REZONING & CERTIFIED SURVEY MAP (CSM) APPLICATIONS

7/11/22 Plan Commission Meeting

Staff Report & Recommendation

SUBJECT: Paul Markiewicz CSM Review

Certified Survey Map No. _____

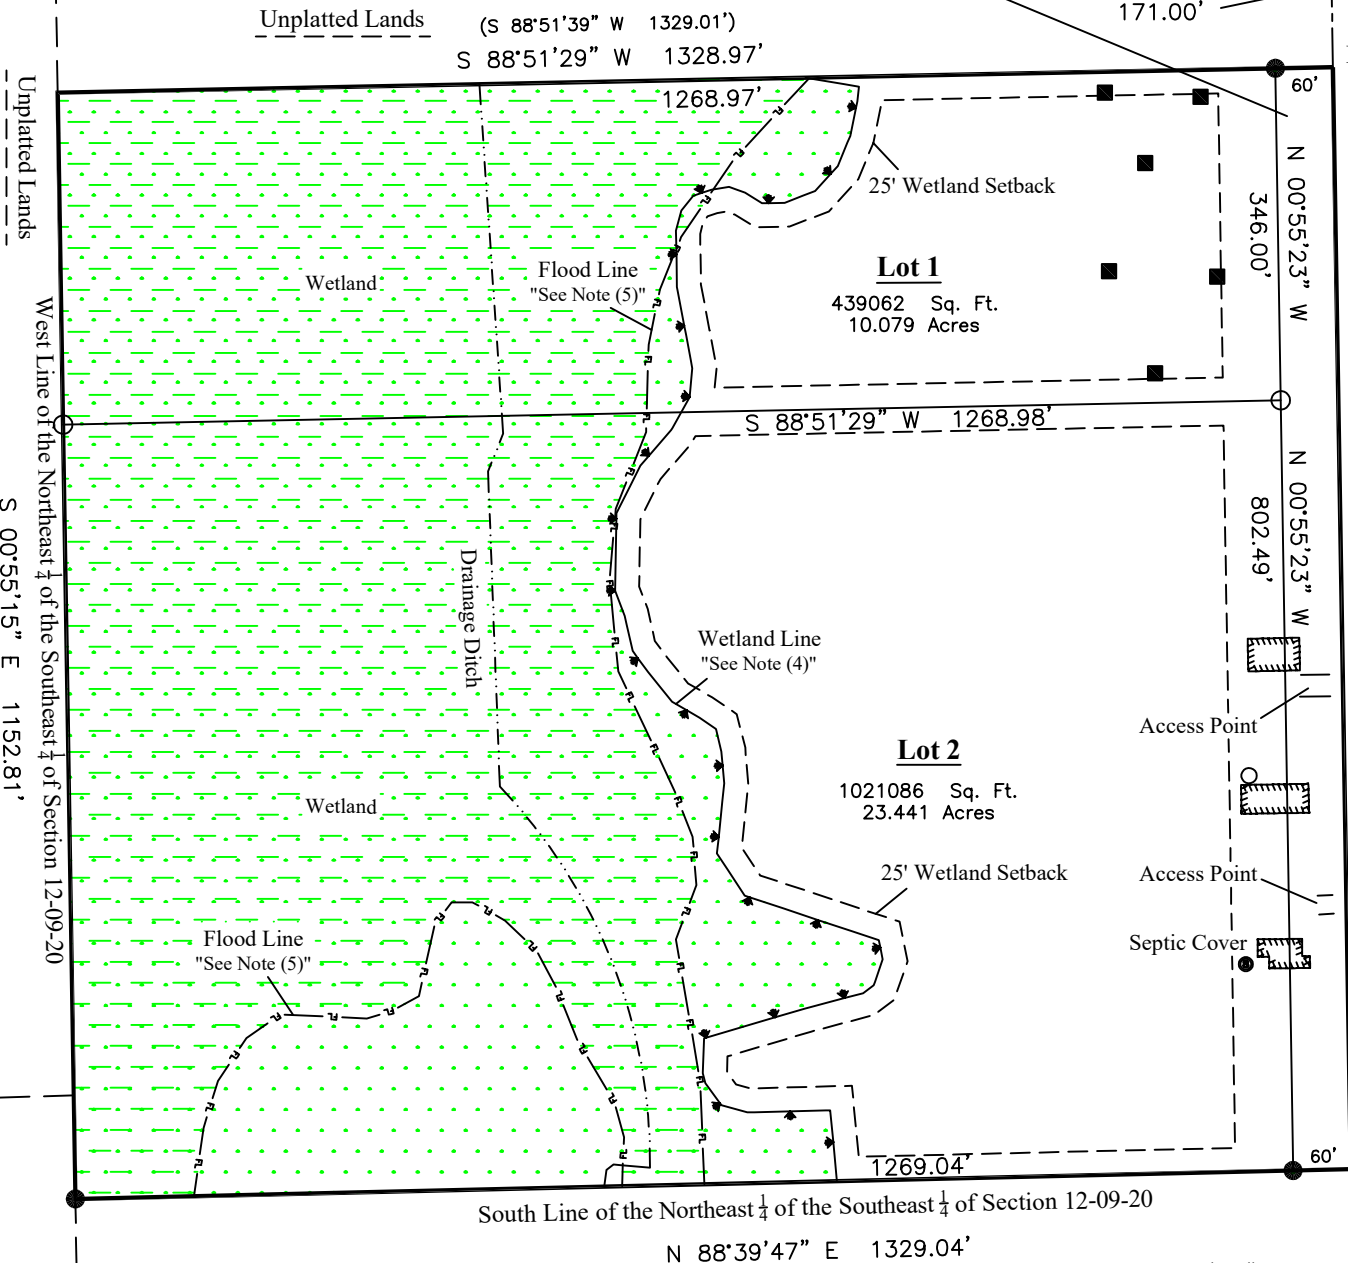
1. Building setback lines are to be mapped and dimensioned.
2. The dimensions along the west line of lots 1 and 2 need to be labeled.
3. The monumentation for the NW corner of Lot 1 should be identified.
4. All existing utility and drainage easements with recording information will be shown and dimensioned.
5. All wetlands will be delineated by an approved and certified wetland specialist.
6. All wetland mapping will be done by a Professional Land Surveyor registered in the State of Wisconsin.
7. Should stream and wetland setback lines be shown on the Certified Survey Map document, the following note will be added:

“Development within these setback areas is prohibited unless otherwise allowed pursuant to the provisions of Chapter 24 (Shoreland-Wetland Zoning Code) in the Germantown Municipal Code.
8. Page 3 should be corrected to read “Plan Commission” rather than “Planning Commission”.
9. A Mortgagee Certificate will need to be included, if applicable.
10. The Owner’s Certificate should include “As Owners, we hereby dedicate that part of Wausaukee Road (CTH M) to the Village of Germantown for public road purposes as represented on Sheet 1 of 4 of this Certified Survey Map”.

"Detail"

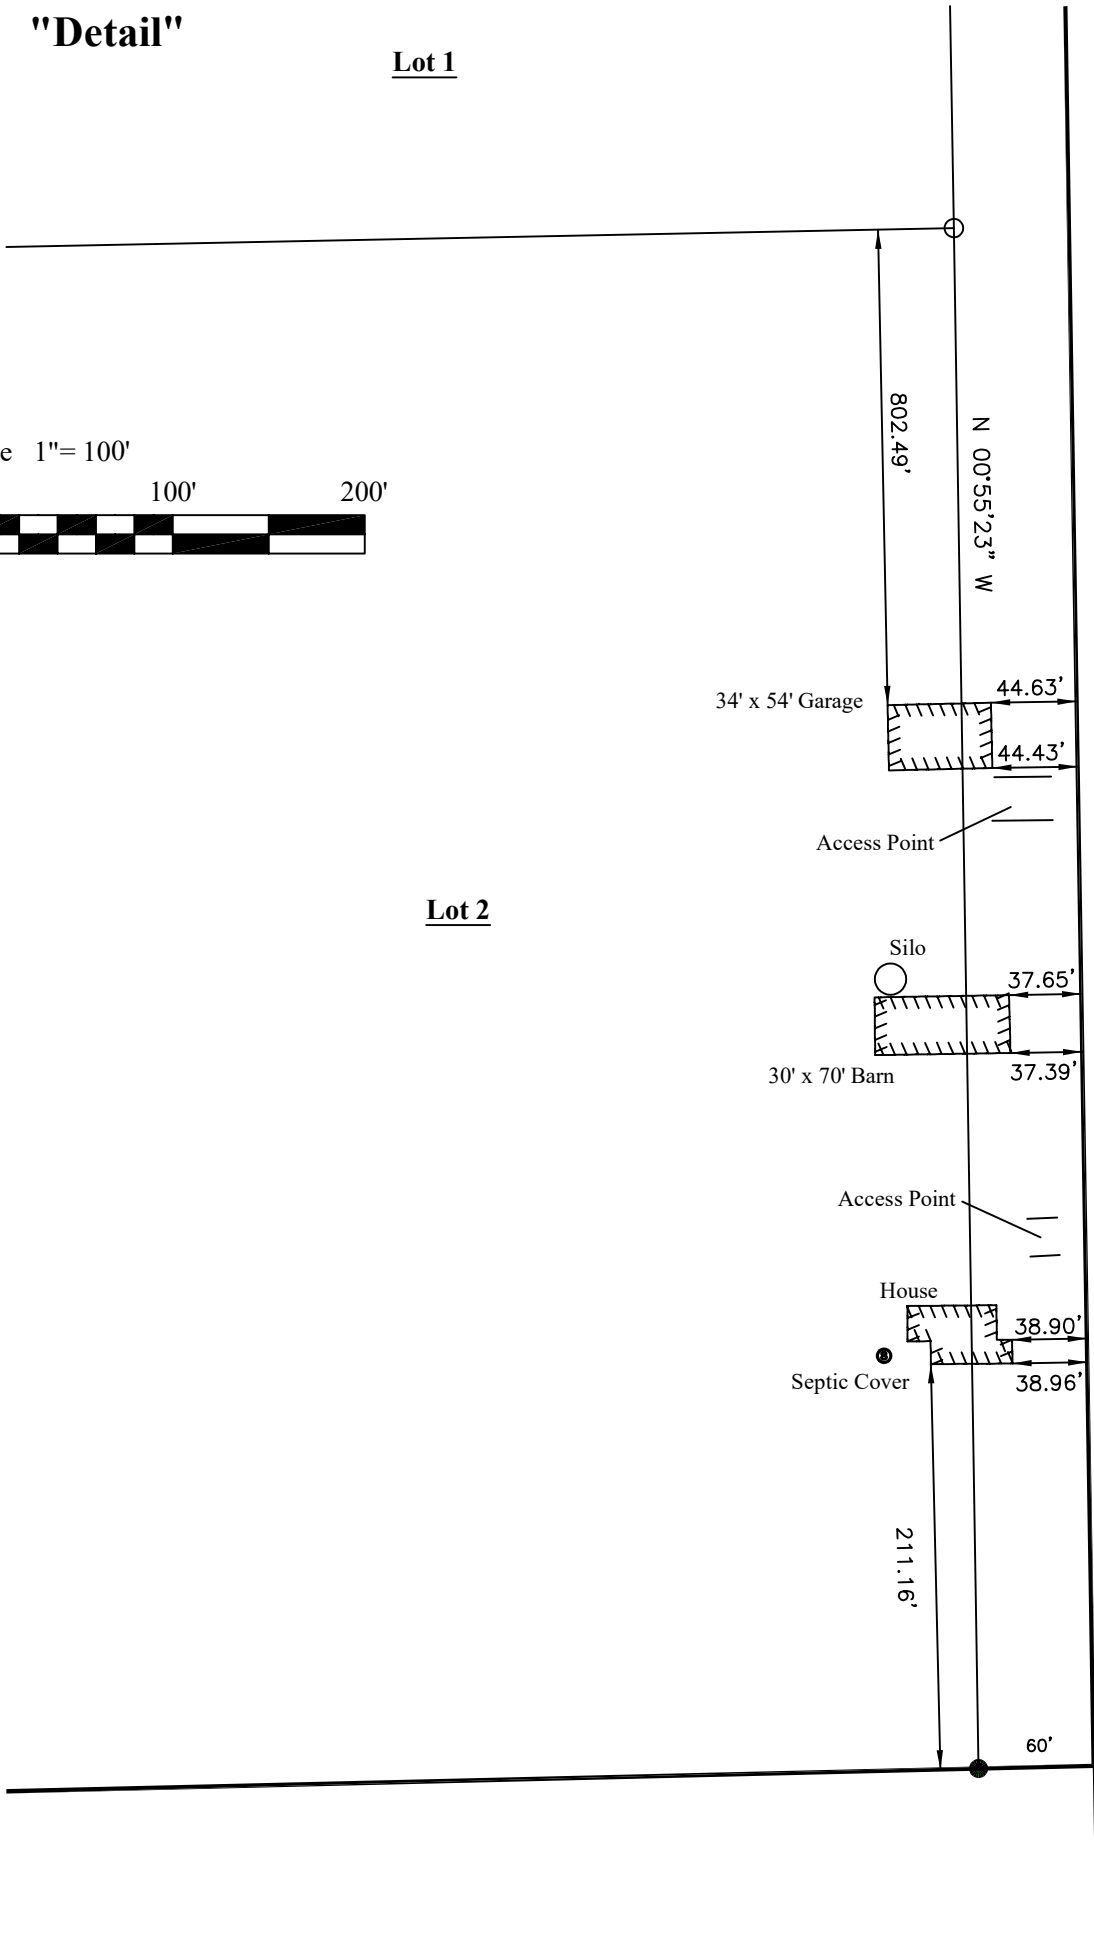
The sight distance along Lot 1 is good for an access along the southern portion of the frontage.

See attached pages about notes to add to the CSM. Please also add a note similar to the following:

Note: One (1) Type A Access is permitted along lot 1 frontage on CTH M.

Owner of lot 1 must make application to Washington County Highway Dept. to

secure required permit. Any future reconfiguration of lot 1 does not result in any additional access points being granted onto CTH M.
